EXTRACT FROM COUNCIL MEETING MINUTES OF MARCH 21, 2017

ZONING BY-LAW AMENDMENT FILE Z.16.044 HATPIN DEVELOPMENTS INC. WARD 1 - VICINITY OF KEELE STREET AND MCNAUGHTON ROAD

COMMITTEE OF THE WHOLE (PUBLIC HEARING) MARCH 7, 2017

2. ZONING BY-LAW AMENDMENT FILE Z.16.044 HATPIN DEVELOPMENTS INC. WARD 1 - VICINITY OF KEELE STREET AND MCNAUGHTON ROAD

Conceptual Site Plan & Zoning

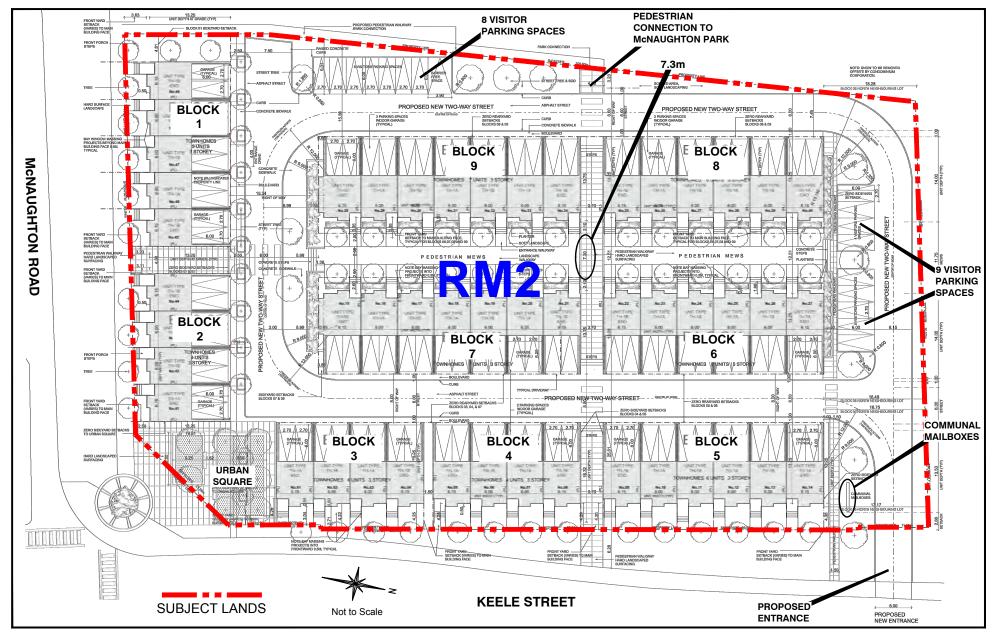
b.	Maximum Number of Units in a Row	6 units	7 units (Blocks 7 and 9 as shown on Attachment #3)
C.	Minimum Width of Landscaping around the Periphery of an Outdoor Parking Area	3 m wide strip of land with a minimum height of 1.2 m	0.7 m with 0 m height

f.	Minimum Front Yard Setback (McNaughton Road)	4.5 m	Ranges between 2.5 m to 3.6 m for Blocks 1 and 2
g.	Minimum Exterior Yard Setback (Keele Street)	4.5 m	Ranges between 3 m to 3.7 m for Blocks 3-5

h.	Minimum Setback to a Sight Triangle	3 m	2 m

Zoning By-law 1-88 Standard	RM2 Multiple Dwelling Zone Requirements	Proposed Exceptions to the RM2 Multiple Dwelling Zone Requirements
i.	Minimum Width of a Landscape Strip	6 m	2 m (McNaughton Road)3 m (Keele Street)

Section 9.2.3.2. in VOP 2010 identifies development criteria for townhouse dwelling units, which states that townhouses shall be up to three storeys in height, not more than six attached residential units in a row and having a minimum facing distance of 18 m. Proposed townhouse Blocks 7 and 9 are designed with seven units in a row, and Blocks 6 to 9 have a proposed facing distance of 12.5m. In accordance with VOP 2010, the Owner has provided an Urban Design Sustainability Brief, to address the development criteria for townhouses, which must be reviewed to the satisfaction of the Vaughan Development Planning Department. Section 10.2.1.7 of VOP 2010 provides for minor variations to numerical standards (except for density and building height), as such, an Official Plan Amendment is not required respecting the proposed 7 unit townhouse blocks (Blocks 7 and 9) and facing distance. The proposed use conforms to VOP 2010. The development proposal will be reviewed to assess consistency with the development and design criteria of VOP 2010. The subject lands are located within the "Village of Maple Heritage Conservation District Plan", and are subject to Section 12.2.1.1c "Heritage Conservation Districts" in VOP 2010. The Vaughan Development Planning Department will work with the Owner to ensure conformity with the Plan.
